**Historical Architectural Review Board  
COA Final Review Sheet**

**HDC-2023-00044**

**Address: 327 N. Nagle Street**

**Proposal: Legalize reconstruction of rear addition (violation correction)**

Photo showing rebuilt wall with door moved.  
(City of Allentown)

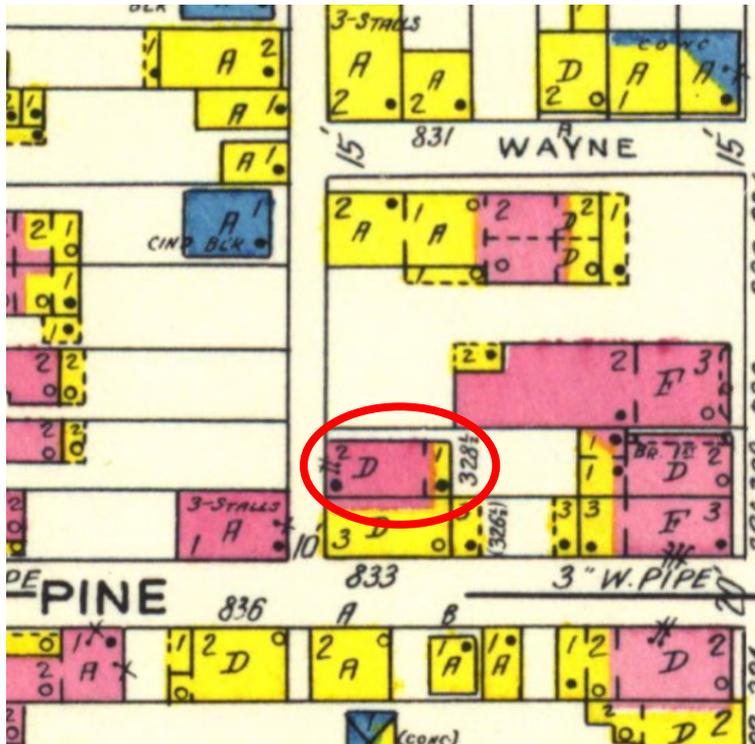
Staff finds that the addition held no architectural or historical significance and was constructed after 1932, though the exact date was not determined. The addition consisted of frame construction and contained no architecturally significant details or features. The north elevation included one second-story window and one entry door at the east end. The rear elevation had one window at each story, and the south elevation contained no openings and was partially visible from Pine Street.

Staff finds that the application is incomplete. To complete its review of the building permit application, Building Standards requested engineering drawings of the framing, and HARB staff additionally requested that the applicant submit photographs of the completed work. The application only includes a hand sketch of the north elevation framing. The sketch contains no dimensions or scale and does not show window or door openings. To review the work, staff requires accurately scaled drawings of all elevations, as requested by Building Standards, along with photographs and/or specs to illustrate the final detailing of the walls. The photographs provided in this application were obtained from Building Standards and show that the work was largely complete, though the rebuilt addition is not in a state such that approval could be provided. The walls are clad with a scratch coat (not finish coat) of stucco, and the door opening has been relocated from the north to the east elevation. An accurate application representing the full extent of work is required to be submitted by the applicant prior to approval.

Denial, owing to incompleteness.
